# Historic Preservation Commission

December 10, 2020

Certificate of Appropriateness

# 1716 2nd Avenue SE – Chimney

# 709 2nd Avenue SE

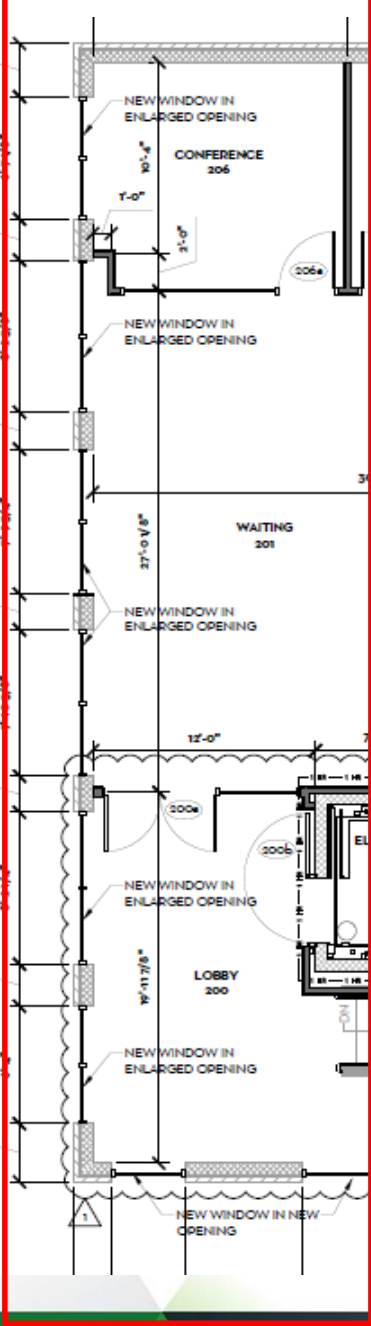
- The structure subject to façade structure modification is a 2 story commercial building built in 1924 per the City Assessor.
- This building is a non-contributing structure to the Automobile Row National Historic District.
- The proposed façade structure modification would resize the six windows on the second story.

- Staff recommends immediate release because this building is a non-contributing structure to the Automobile Row National Historic District.
